Our Reference: JW21070

**RE: Response to RFI for RC230340**

Thank you for your consideration of resource consent application RC230340. Please see a response to your request as follows:

Figure 1: Extract of Title plan detailing Right of Way areas.

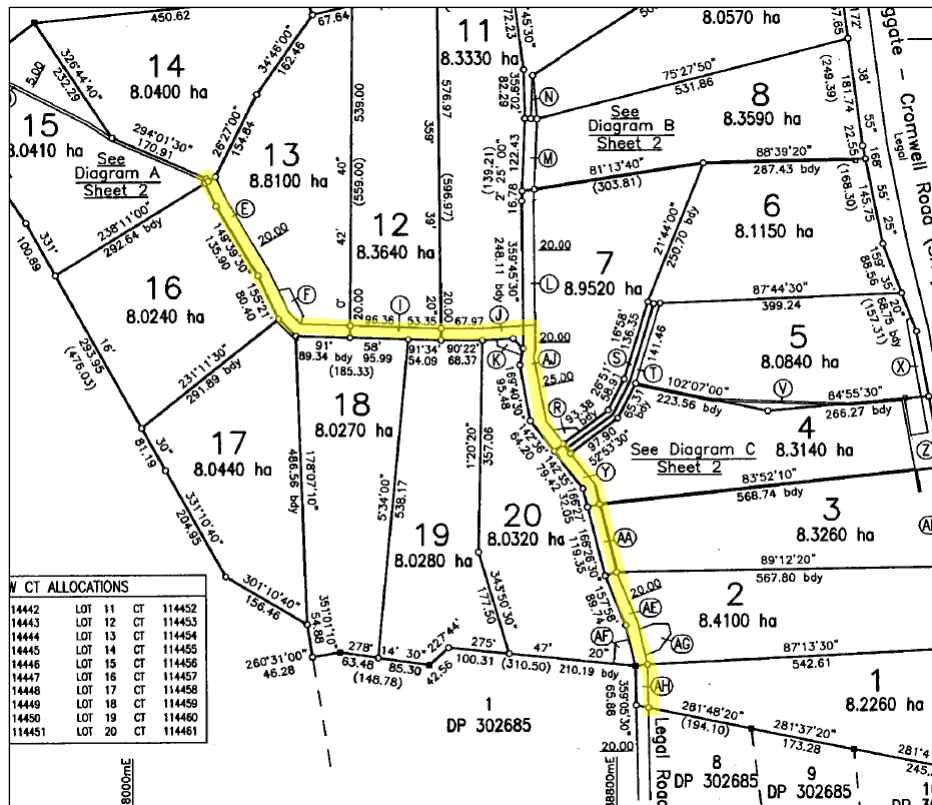
**3. Queensberry Irrigation Company appears to maintain the ROW (Queensberry Terrace/Totara Place) currently. Please show the extent of ROW AH, AE, AA, Y, AJ, L, M, N, J, I and E covered by the Water Supply and Right of Way Maintenance Agreement dated 20 February 2012.**

Please see below an extract of the Title plan showing the ROW as requested. I have attached a copy of the Title Plan in **Appendix [B]**:

*Figure 2: Photo looking into gully showing 4.5 metre pole at base of gully for reference.*

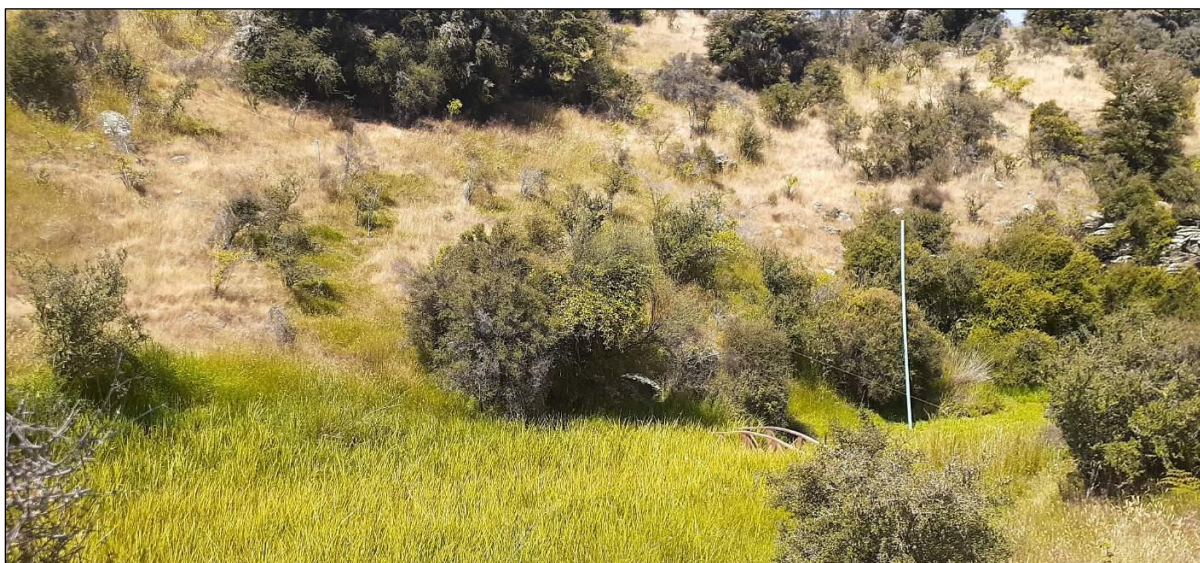
**9. The application states that there are no hazards identified for the site, but the Otago Natural Hazards portal shows a fan form channel flowing through the gully system. Please provide an assessment of this.**

There is no survey of the gully floor in relation to this site however the applicant erected a 4.5 metre pole in the gully which does not reach around halfway up the gully to the terrace in which the activities are proposed. Coupled with existing residential dwellings located at the same elevation as the proposed dwelling site and no report flooding concerns, it is considered unlikely that the gully poses a risk to development in terms of flooding/flows.
